## HISTORIC PRESERVATION COMMISSION

Date: December 6, 2007

SUBJECT: Historic Area Work Permit #468507, driveway alterations, brick wall removal, and brick walkway installation

Address: 9 West Lenox Street, Chevy Chase

Serpentine brick wall to remove  
Adjacent to 'turn around' AREA

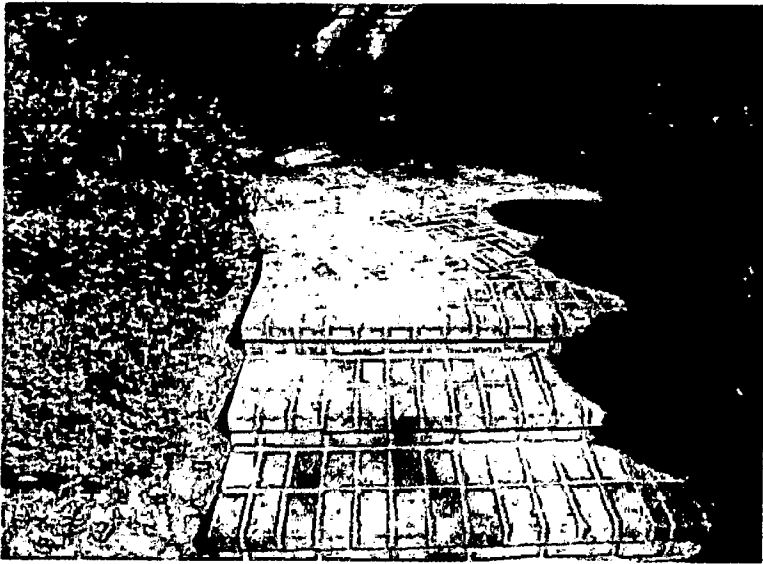
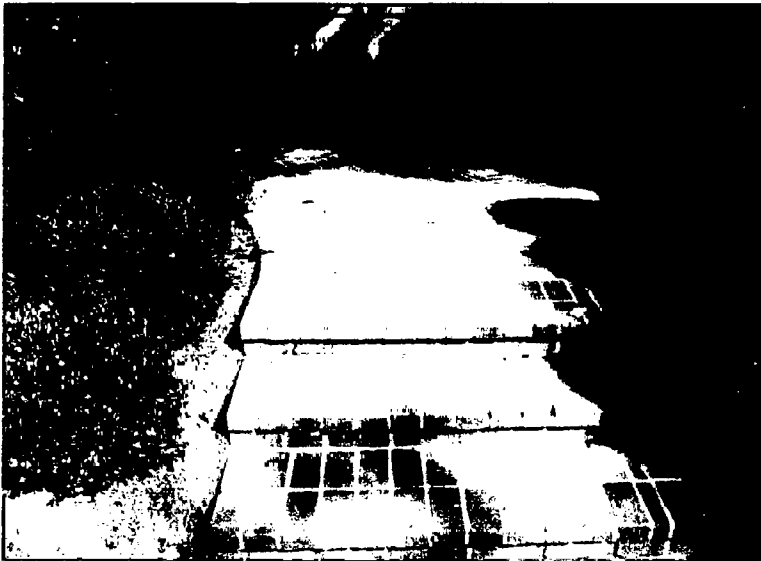
One member noted in agreeing with the staff's recommendation that this project should be approved, as follows" In addition to other improvements, I believe that the removal of the wall, constructed in 1990, will improve the streetscape and provide an uninterrupted view of this interesting and attractive historic property."

Another member supported the approval but wanted to clarify for staff as follows: "...note that any reliance by the HPC on the staff report's suggestion that "proposed use of vegetative screening will minimize its visibility from the public right-of-way" would be inconsistent with "Rule 1" of the Guidelines, which states:

DRIVEWAY ELEVATION  
BRAYNES VANZE ARCHITECTS  
05-18-11

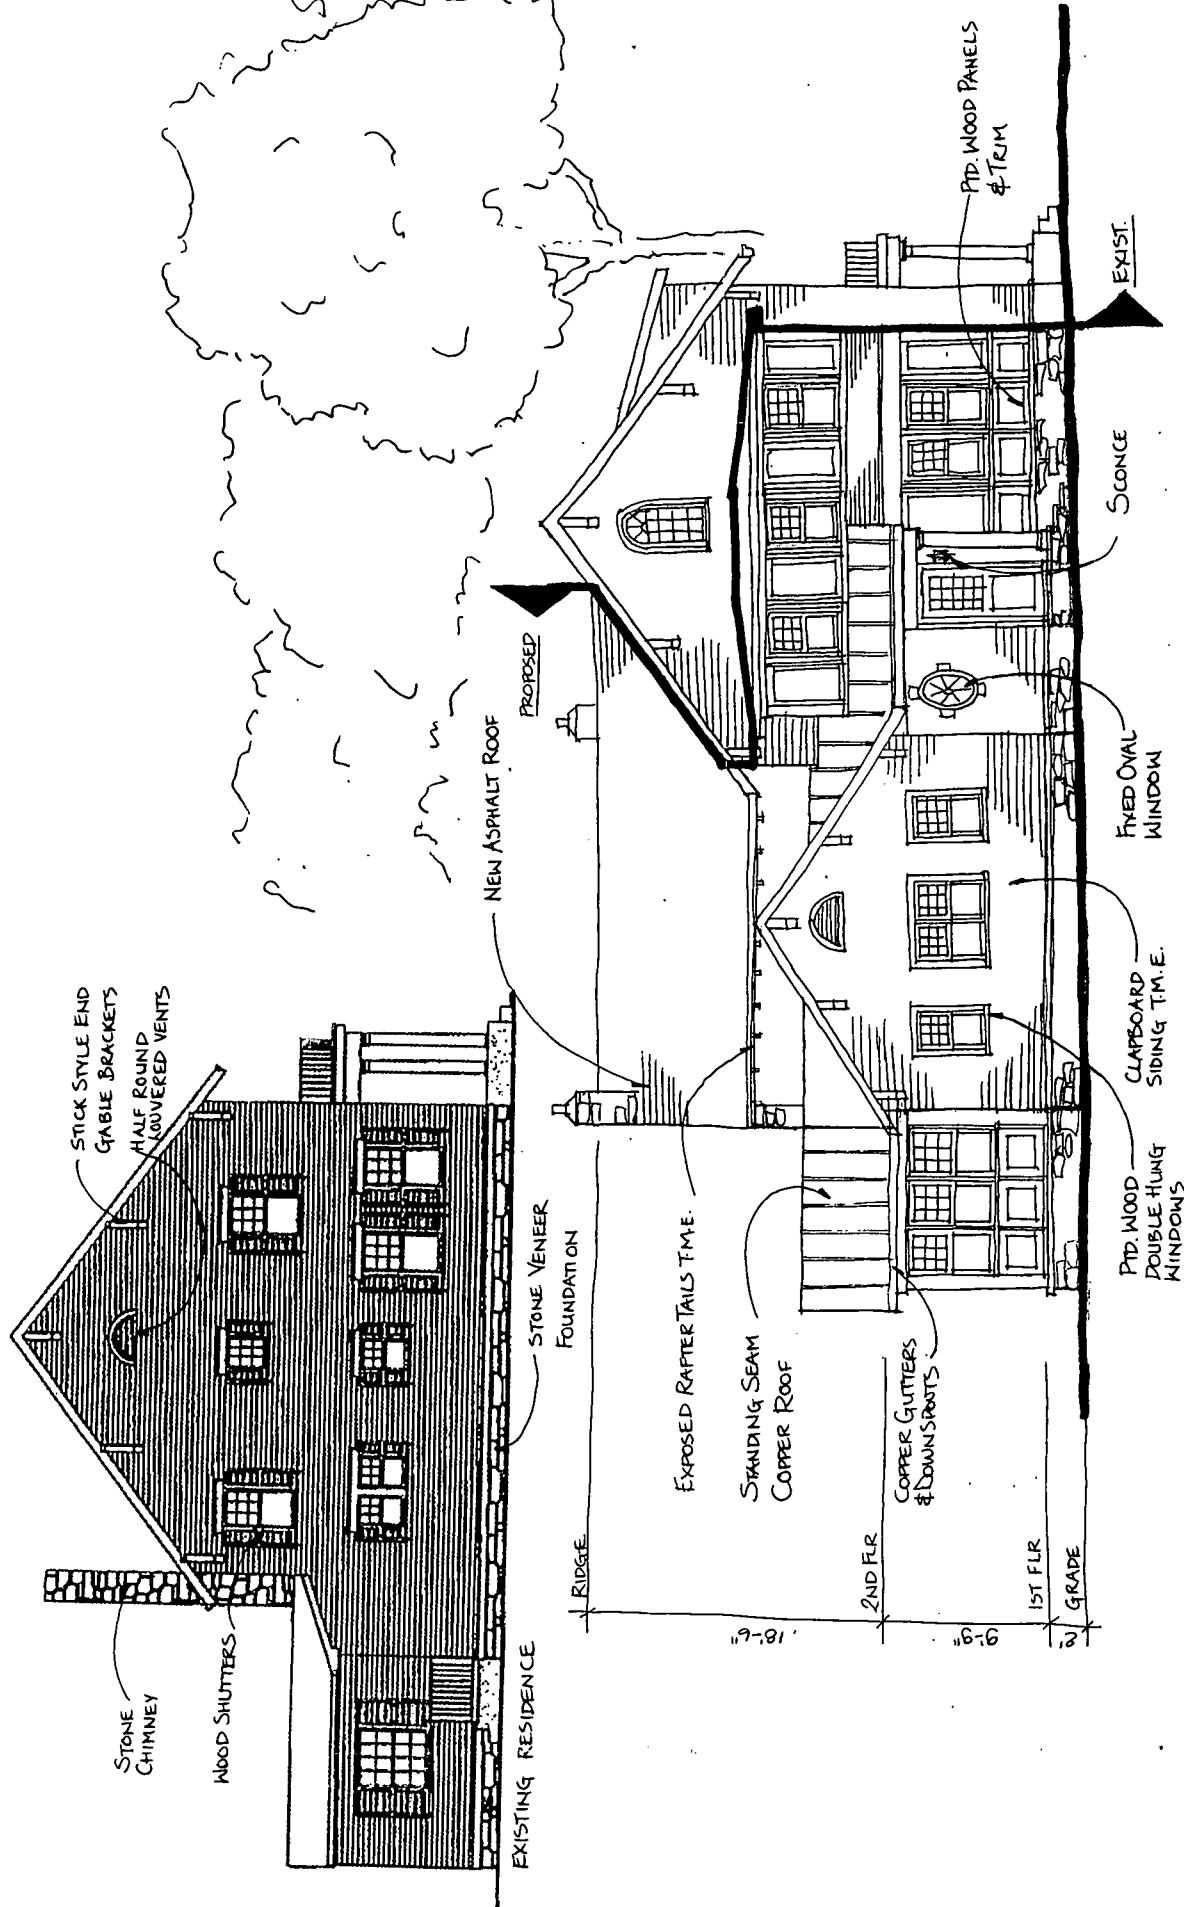
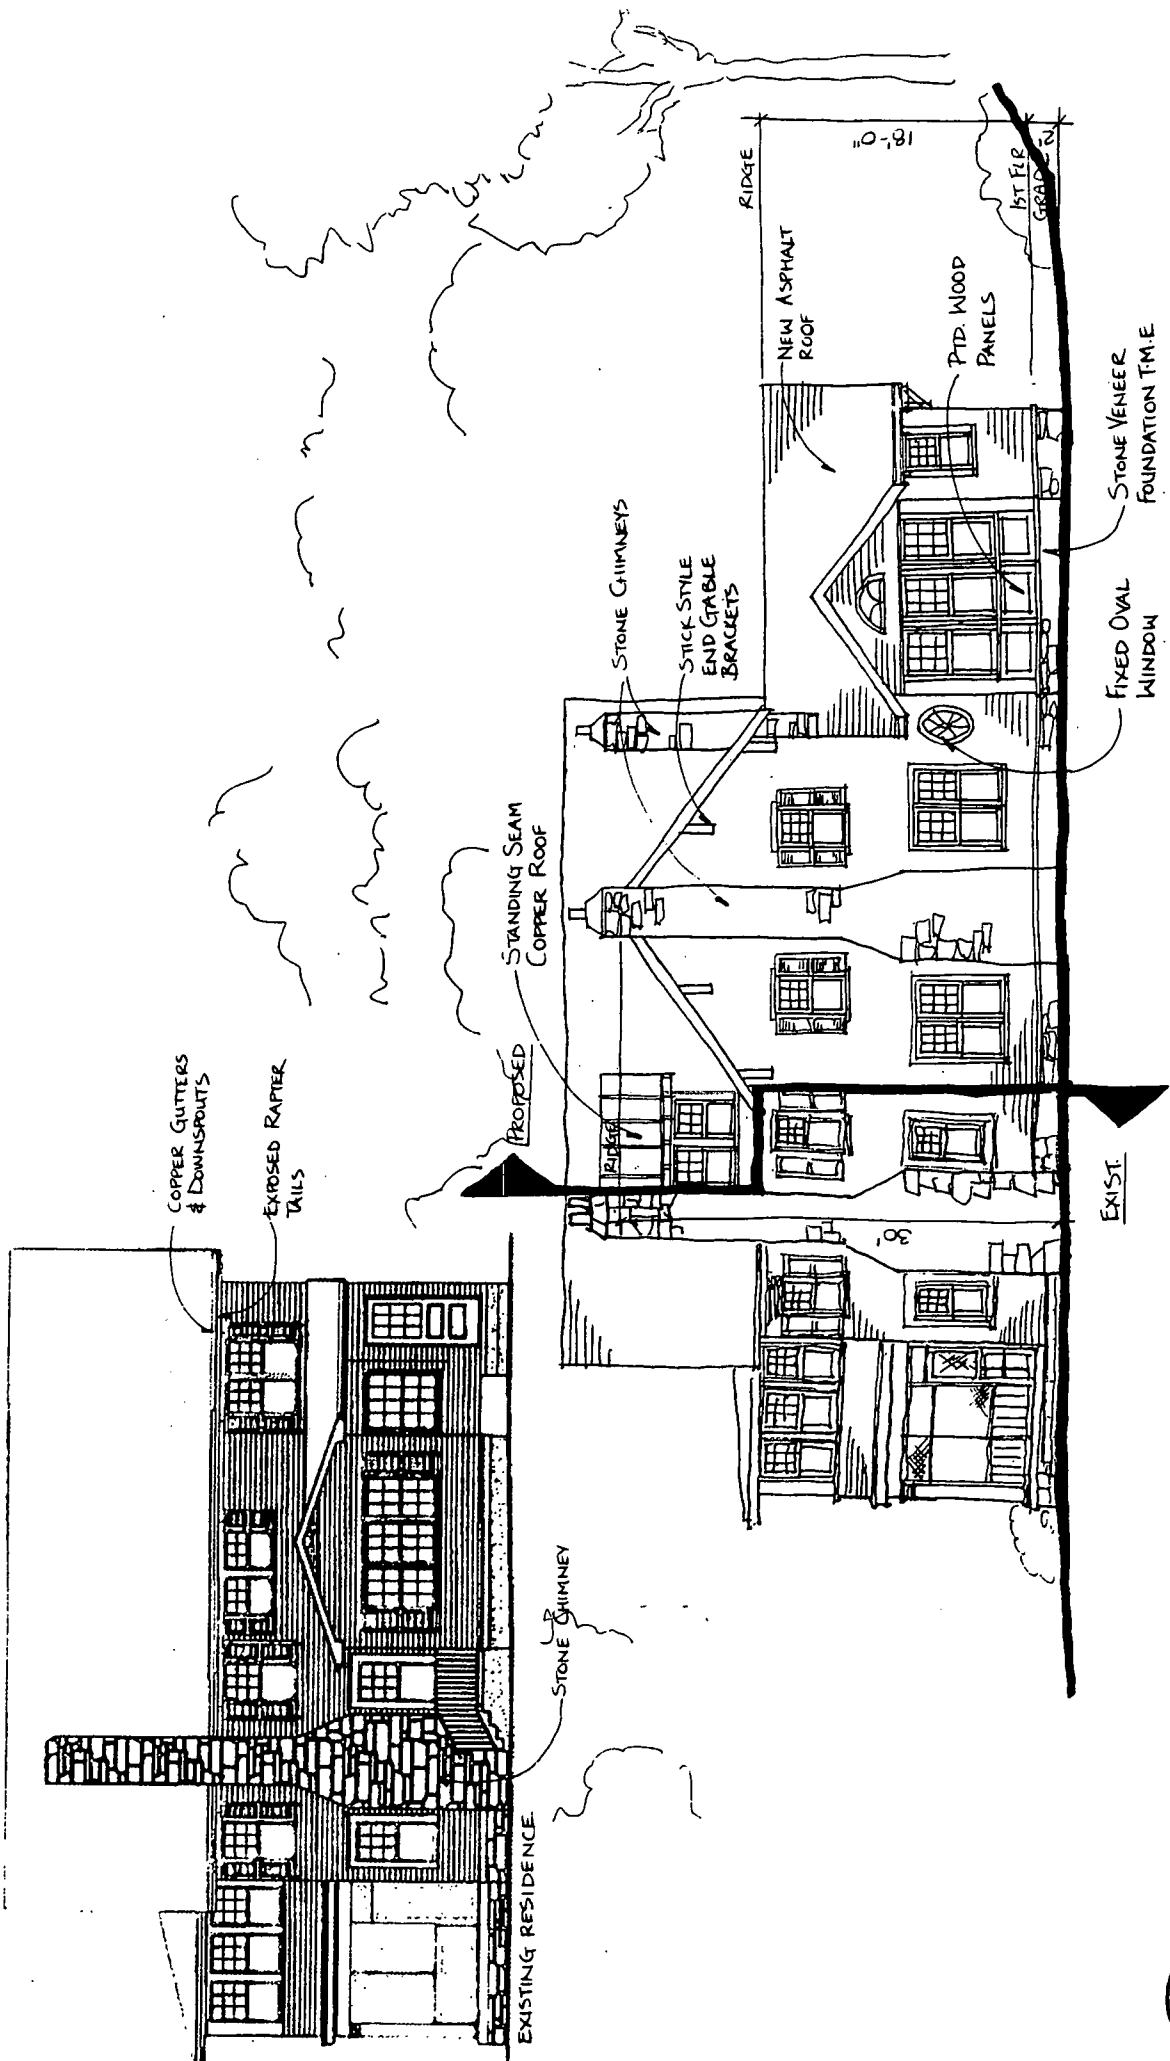
The proposed work also includes reducing the width of the existing side yard driveway that provides access to a rear yard garage. The existing driveway tapers from 12'1" -to- 9'8" along the side of the house and widens to 16'2" in front of the garage. The proposed driveway design maintains the dimensions at the public right-of-way and in front of the garage and calls for an 8' wide driveway with 1'0" +/- planting bed between the proposed addition and driveway.

4 This is our proposed massing from a similar  
5 volume, sorry, similar vantage point where you can see how  
6 our garage is somewhat obscured but still visible along the  
7 driveway. I'll mention briefly that the driveway dimension  
8 being narrowed as acutely as described in the staff report  
9 is, of course, because we are proposing an 18-inch planter  
10 on the side. Certainly, we could reduce the width of the  
11 planter a bit to keep the driveway line where it is and  
12 actually make it a little more usable than was described.

SITE PLAN  
 BARNES VANZE ARCHITECTS  
 05.18.11  
 1/8" = 1'-0"

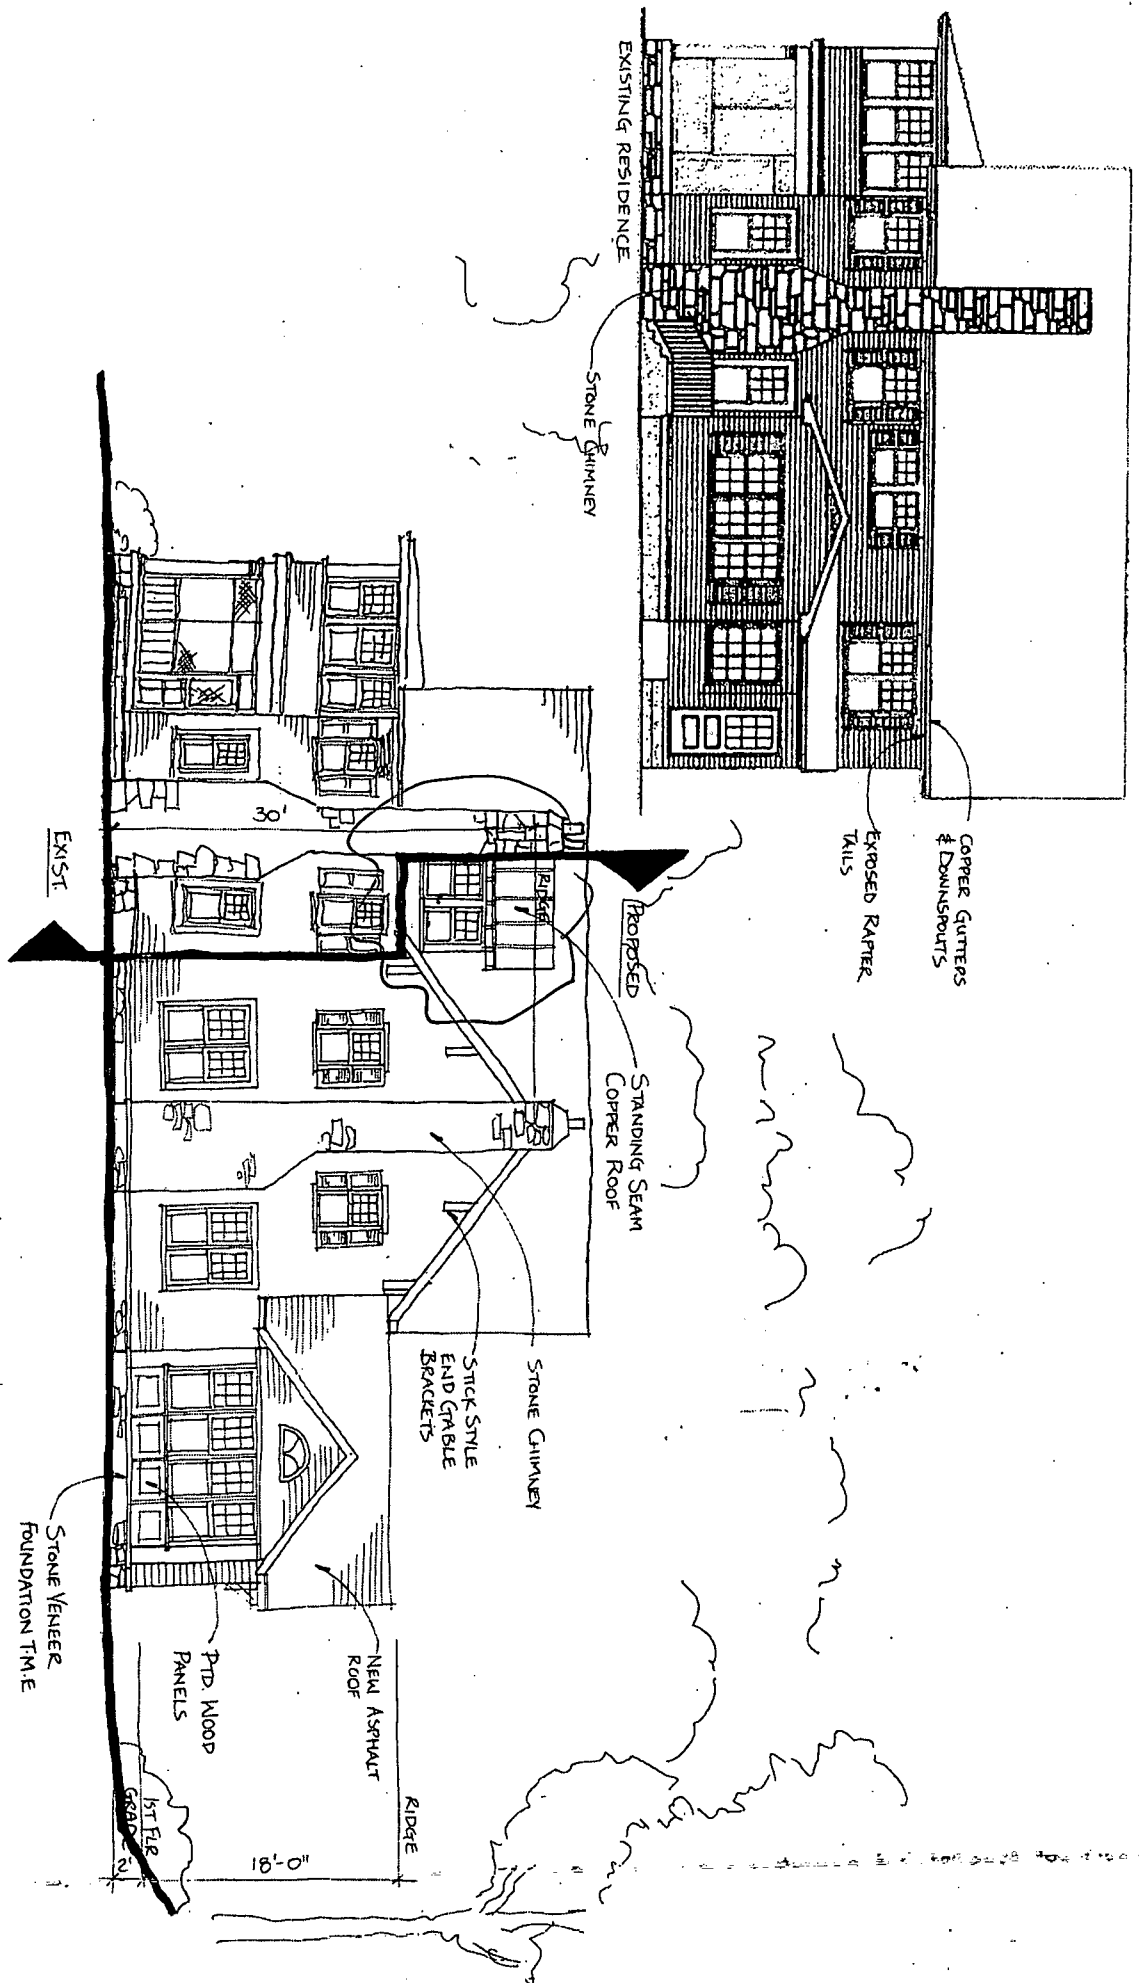
Also, regarding 20 West Lenox Street, the arborist has determined that the White Oak on the property line with 18 West Lenox Street will require a thirteen (13) foot radius of tree preservation (not from the center but around the trunk). Because this encroaches on the current plan as submitted by the resident, the Board required that a boundary survey be provided by the resident and that any proposed addition accommodate this radius prior to issuance of the permit.

8 It says, regarding 20 West Lenox Street, the arborist has  
9 determined that the White Oak on the property line with 18  
10 West Lenox Street, will require a 13 foot radius of tree  
11 preservation (not from the center but around the trunk).  
12 Because this encroaches on the current plan, as submitted by  
13 the resident, the Board required that a boundary survey be  
14 provided by the resident and that any proposed addition  
15 accommodate this radius prior to issuance of the permit.

13 So we are prepared to commit to preserve the 13  
14 feet as the neighbor's request. And to also work with the  
15 consulting arborist and the Village arborist and the  
16 neighbors as we proceed with the plans for the construction.

EXIST. WHITE OAK (50" D)  
 VILLAGE ARBORIST HAS REQUESTED A 13' RADIUS ROOT PROTECTION ZONE FROM FACE OF BARK.
